Ref: GW21039255

Re: SSD 46014456 Concept Proposal and Stage 1 application for a new independent school in North Sydney – Submission

RE: Transport Response to the Reddam House State Significant Development Application (SSD-46014456),

Figure 3: On-site drop-off and pick-up area (Source: ARUP OTMP)

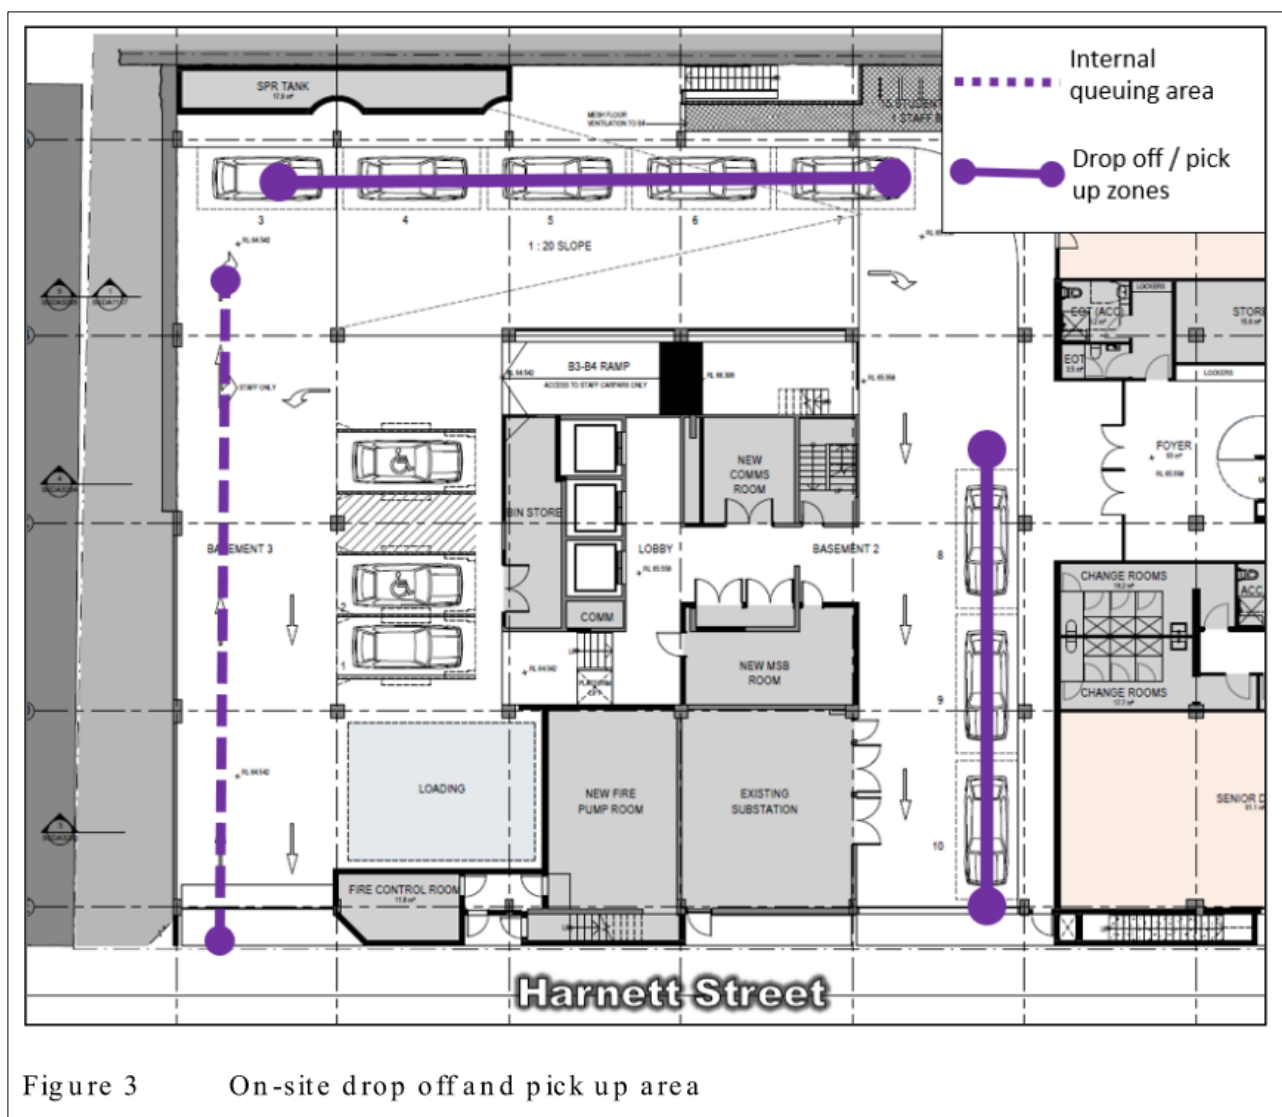
Our review of the layout and swept paths included in the TIA, highlight the following matters:

- It is unclear where the staff member(s) will be positioned to view student names on vehicles and summons students. The procedure assumes parents arriving for pick up will provide the student(s)' name to a staff member, which means the staff member needs to be standing to the right side of the vehicle (driver being on the right side of the vehicle). Alternatively, student names could be positioned in the left corner of the windscreen for the staff to read. A third option (particularly for parents picking up siblings across the junior and senior school) may require parents to park in a bay and leave the vehicle to approach a staff member located close to the drop off pick up bays to ask a staff member to summon the student(s). This procedure is likely to require more than 80 seconds on average during the PM pick-up time.

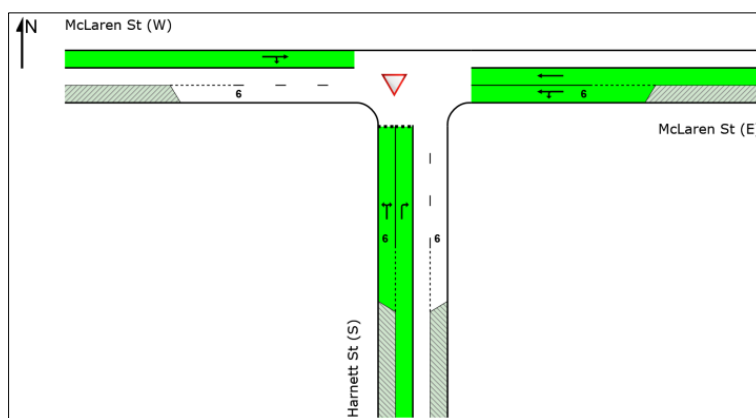
We have also identified several errors in the SIDRA modelling which require clarification and correction to allow an accurate assessment of both the Concept Plan and the Stage 1 development to be completed.

The traffic assessment has been modelled in SIDRA based on June 2022 traffic counts, which have been factored up to pre-pandemic traffic volumes from 2018. We presume this method has been adopted to reflect changes in local traffic conditions and possibly due to nearby Sydney Metro works. It is unclear whether the June 2022 traffic counts were undertaken well clear of the end of Term 2. Traffic data has also not been provided in the TIA to validate how the June 2022 counts were factored up. The report does not detail whether the factoring up of traffic data incorporated traffic generation associated with recently approved education uses, particularly where the AM and PM peak periods are expected to coincide with Reddam House, even with the proposed staggered start / finish times.

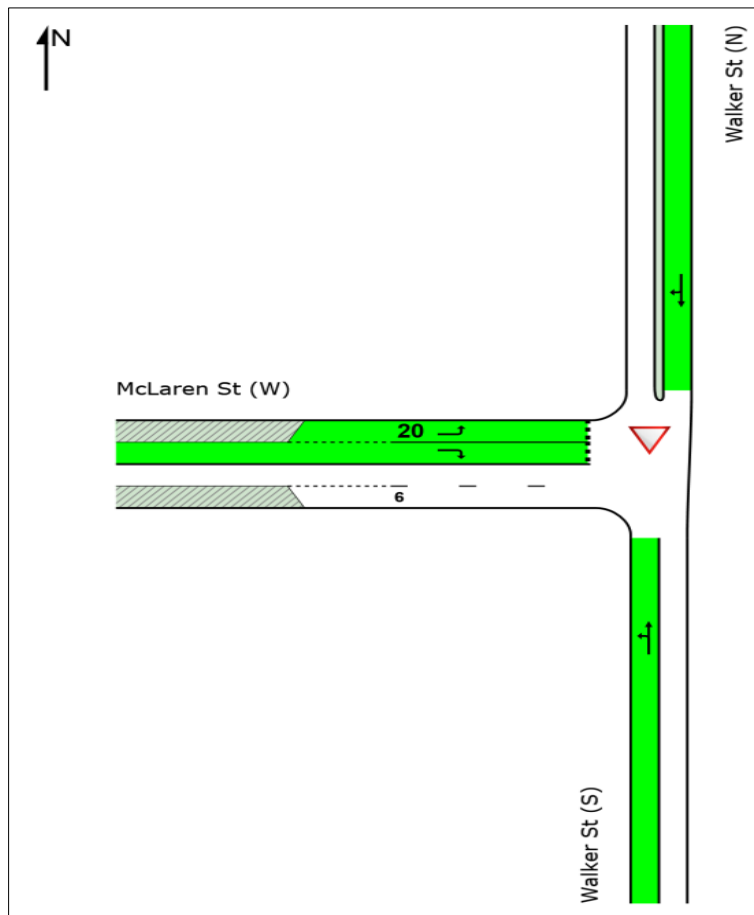
- The default assumption of 50 pedestrians per hour requires validation by surveyed pedestrian volumes and forecasted pedestrian volumes, particularly as the modelled intersections must account for pedestrians attributed to schools, workers and residents in the North Sydney CBD;
- The SIDRA-modelled layout at the Harnett Street / McLaren Street intersection is incorrect, thereby skewing the results. In particular:
 - Harnett Street is only 7m wide and cannot accommodate 4 lanes;
 - Harnett Street approach should be modelled as shared left and right turn lanes; and
 - The westbound approach should be modelled as shared left and through lane.

- The SIDRA-modelled layout at the McLaren Street / Walker Street intersection is incorrect thereby skewing the results. In particular:
 - The McLaren Street approach should be modelled with a Stop control, rather than a Give Way control given the number and range of traffic movements; and
 - The 6m short land on the westbound receiving land should be removed.
